Product Change Notification

Product Group: OPT/Tuesday August 4, 2026/PCN-OPT-1505-2026-REV-0

Qualification of new chipset in VO14642AT and VO14642AABTR solid state relay

Fig. 8 - LED Forward Current for Switch Turn-On vs. Ambient Temperature

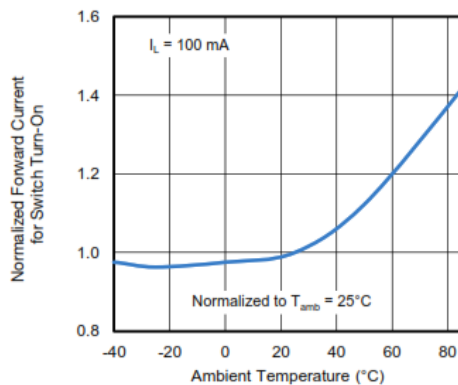
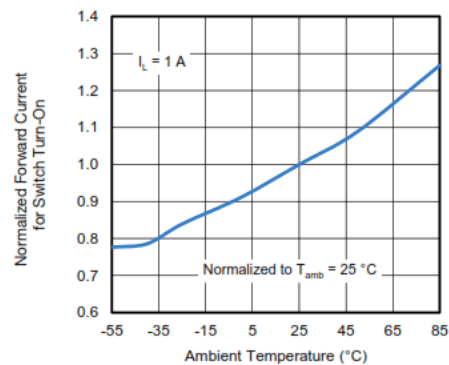
Expected Influence on Quality/Reliability/Performance: There is no change in form, fit and function of the affected parts. The performance as well as the reliability remains unchanged. The min and max parameters remains unchanged. The deviations in the typical performance parameters are highlighted in the attached comparison report.
